From: [Debra M. Beckwith](#)
To: [BR](#)
Subject: Bridge Advertisement (DSI 22-033) CIP Pile backing ring dimension
Date: Friday, April 28, 2023 1:24:52 PM
Attachments: [image001.png](#)

The [Bridge Standard Drawings](#) have been updated as described below:

STEEL PIPE PILE SPLICE

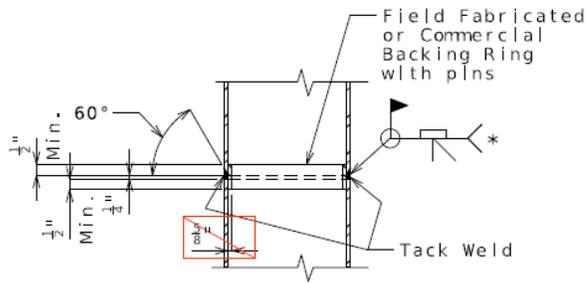
Revision Date	Items Revised	Description of Change
Apr. 2023	EPG: NA	Updated Bridge Standard Drawings PILE01 and PILE02 to remove backing ring size requirement. Contractor will use field fabricated or commercially available backing ring of their chosen thickness to construct steel pipe pile splice. (See marked up detail below)
	Bridge Standard Drawings: PILE01 & 02	
	MicroStation Cells: NA	
	Std. Specifications: NA	
	Standard Plans: NA	
	Bridge Special Provisions: NA
